Hope Creek Generating Station  
Facility Operating License No. NPF-57  
NRC Docket No. 50-354

Subject: Responses to Requests for Additional Information  
Request for License Amendment - Extended Power Uprate

**Extended Power Uprate**

**Response to Request for Additional Information**

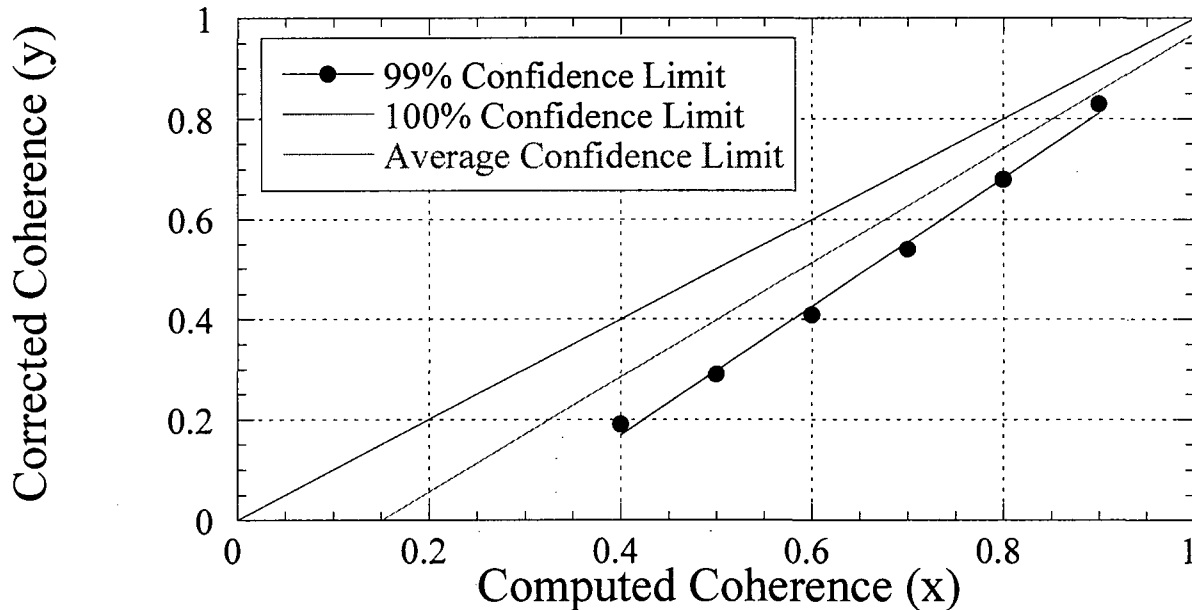
The PSEG response does not provide the basis for correcting the coherence between **[[**

The reference J. S. Bendat and A. G. Piersol, 1966, Measurement and Analysis of Random Data, John Wiley and Sons, Page 215, Table 5.1 (described in C.D.I. Report No. 07-09P) gives 99% confidence limits on the coherence based on coherence estimates, as provided in our previous response to this RAI:

A plot of these data gives the following:

where a linear curve fit through the data points (black circles) gives the line  $y = -0.346 + 1.286x$  ( $R^2 = 0.995$ ) in black, the one-to-one curve (no correction) in blue, and the line halfway between the linear curve fit and no correction (halfway to the lower confidence limits, identified in the figure as the average confidence limit) in red. The average confidence limit recovers a corrected coherence that is more conservative (a higher value) than use of the 99% confidence limit as suggested in the data of Bendat and Piersol, as it follows from the equation  $y = -0.173 + 1.143x$ . For example, if the computed coherence between the upper and lower strain gage measurements is 0.6, no correction would leave the coherence at 0.6, use of the 99% confidence limit curve would give a corrected coherence of 0.4, while an average coherence value would give 0.5. The average values are used in the analysis.
